The Commission has issued the enclosed Amendment No. 33 to Facility Operating License No. DPR-28 for the Vermont Yankee Nuclear Power Station. The amendment consists of changes to the Technical Specifications in response to your application dated November 9, 1976.

This amendment revises the pressure-temperature limitations in order to comply with 10 CFR Part 50, Appendix G, "Fracture Toughness Requirements." It also establishes a surveillance capsule removal schedule to assure compliance with 10 CFR Part 50, Appendix H, "Reactor Vessel Material Surveillance Program Requirements."

Amendment No. 33  
License No. DPR-28

ATTACHMENT TO LICENSE AMENDMENT NO. 33

FIGURE 3.6.1  
 REACTOR VESSEL PRESSURE  
 TEMPERATURE LIMITATIONS  
 for operation through  $8.0 \times 10^7$  MWH(t)  
 $RT_{NDT}$  @ 1/4t = +70°F @ 3/4t = +65°F

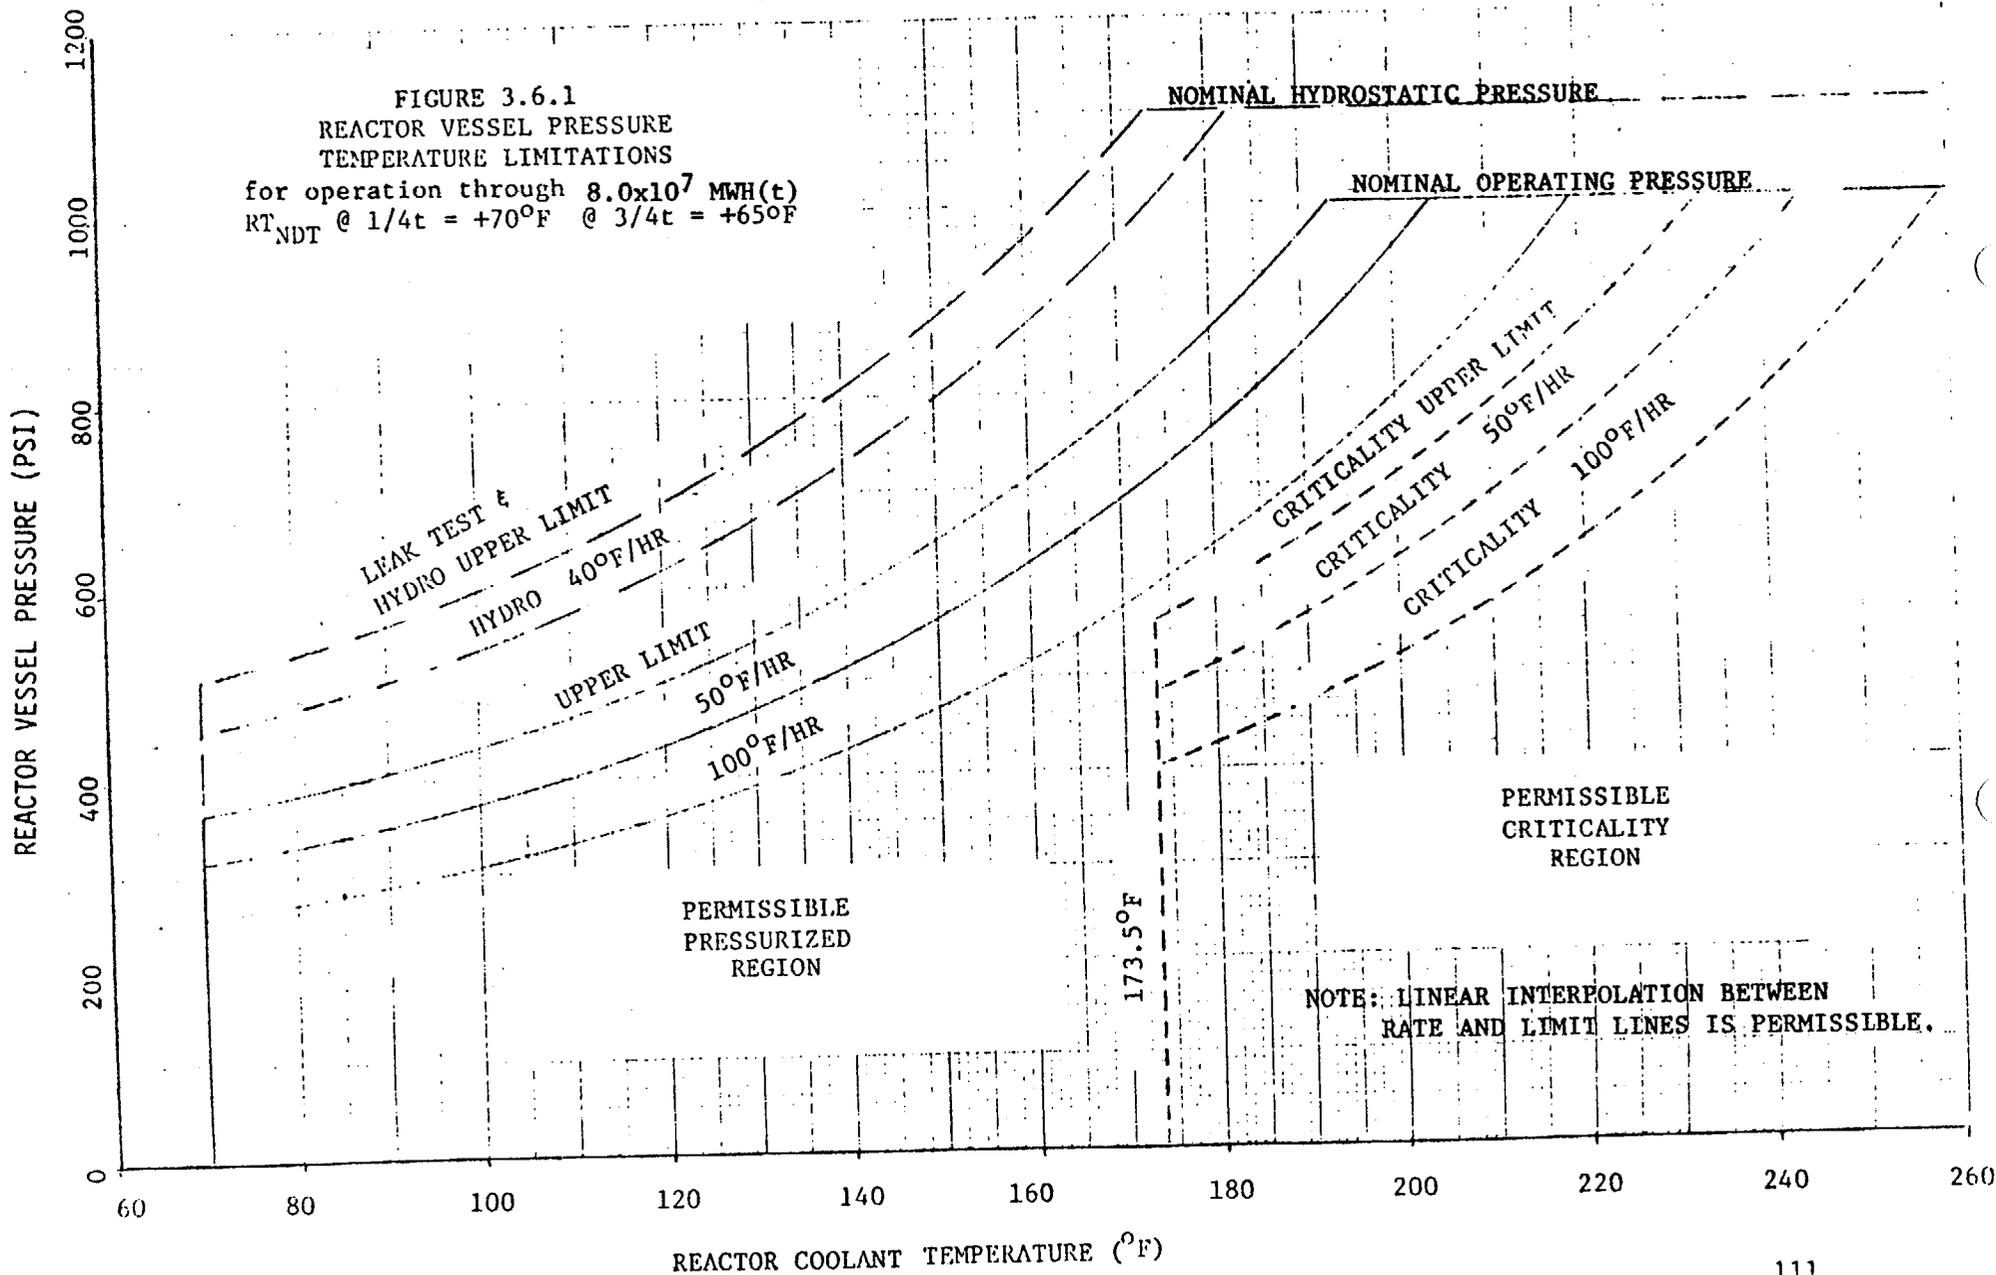
1. The reactor coolant system temperature and pressure shall be limited in accordance with the limit lines shown on Figure 3.6.1 during heatup, cooldown, criticality (except for the purposes of low power physics testing), and in-service leak and hydrostatic testing.
2. The maximum heatup or cooldown rate is 100°F when averaged over any one hour period.
3. The reactor vessel head bolting shall not be tensioned unless the temperature of the vessel head flange and the head is greater than 70°F.
4. The pump in an idle recirculation loop shall not be started unless the temperatures of the coolant within the idle and operating recirculation loops are within 50°F of each other.

The pressure-temperature limit lines shown on Figure 3.6.1 for reactor criticality and for inservice leak and hydrostatic testing have been provided to assure compliance with the minimum temperature requirements of Appendix G to 10 CFR 50 for reactor criticality and for inservice leak and hydrostatic testing.

VYNPC proposed a revision to Technical Specification 3.6/4.6A, "Pressure and Temperature Limitations," for VYNPS. The proposed operating limits were calculated in accordance with Appendix G, 10 CFR Part 50, and Standard Review Plan 5.3.2 which includes Branch Technical Position MTEB 5-2. These new operating limits were based on a fluence at the vessel wall inside diameter of  $2.9 \times 10^{17}$  neutrons per square centimeter ( $n/cm^2$ ) and calculated for operation through  $1.3 \times 10^8$  megawatt hours thermal (MWH(t)), approximately 13 effective full power years (EFPY). At this point in time the limiting reference temperature ( $RT_{NDT}$ ) of the vessel was calculated to be 70°F. We find that the calculations performed were in accordance with 10 CFR Part 50, Appendix G, and are therefore acceptable. The basis for the fluence estimation was an analysis performed by Southwest Research Institute on a vessel wall dosimeter removed from the vessel in October 1974. This analysis is presented in Southwest Research Institute Report SWRI Project 02-4032, May 23, 1975. We find that their estimate for fluence at the vessel wall at end of life may be low in view of higher values now estimated for similar facilities. On this basis, we have reduced the time period relating to the pressure-temperature limits proposed in Technical Specification 3.6/4.6A and Figure 3.6.1 from  $1.3 \times 10^8$  MWH(t) to  $8.0 \times 10^7$  MWH(t). We have discussed this change with VYNPC and they have agreed. Based on this change, we conclude that the resulting values and the calculational methodology employed are acceptable.

FIGURE 3.6.2

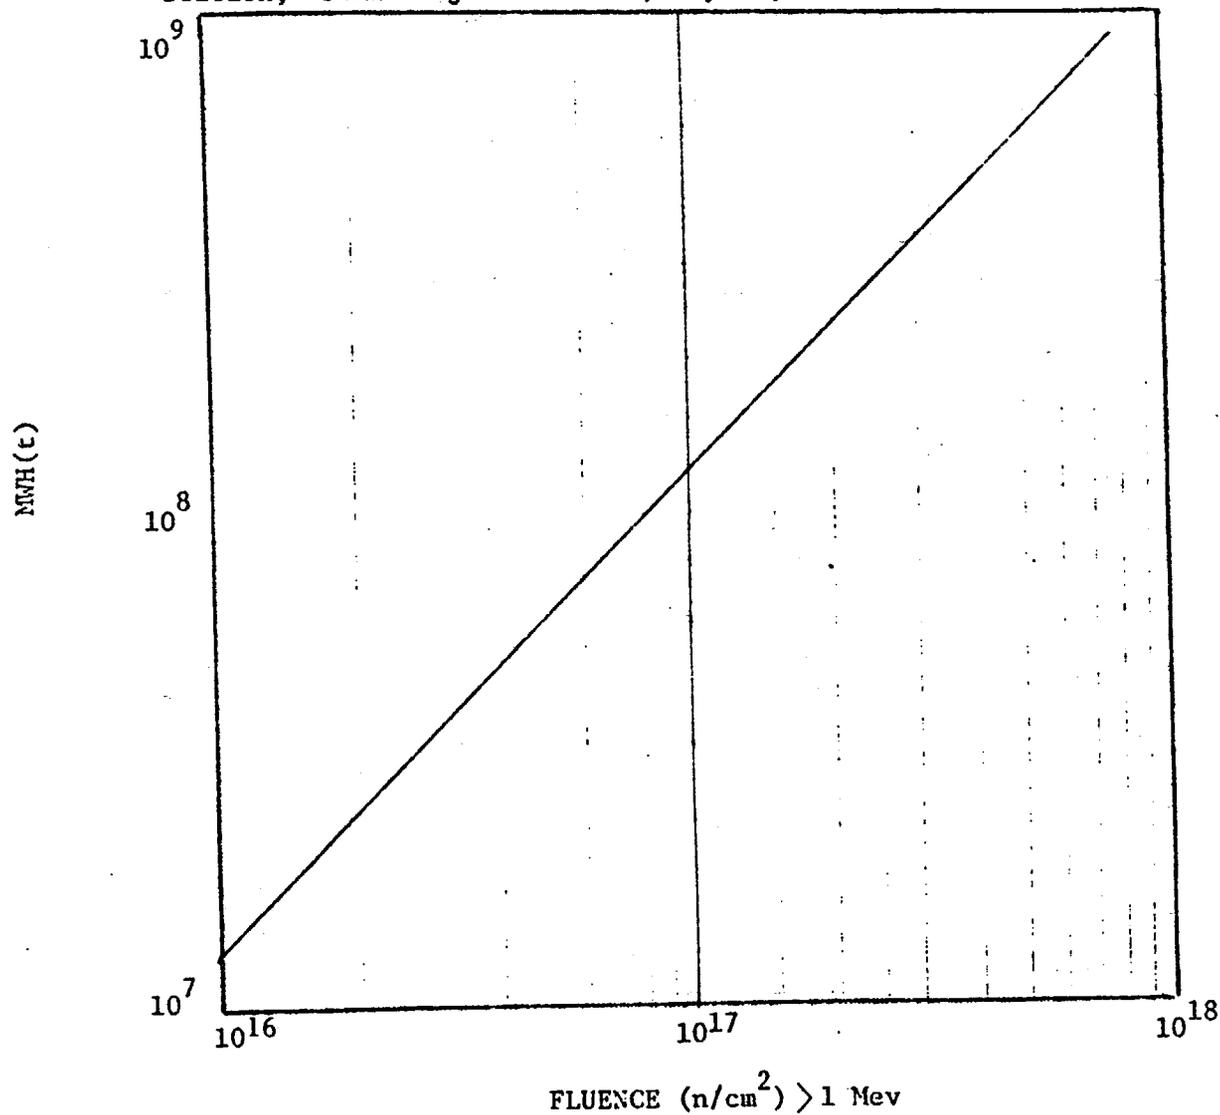
The results shall be used to update Figures 3.6.2 and 3.6.3. The removal times shall be referenced to the refueling outage following the year specified, referenced to the date of commercial operation.
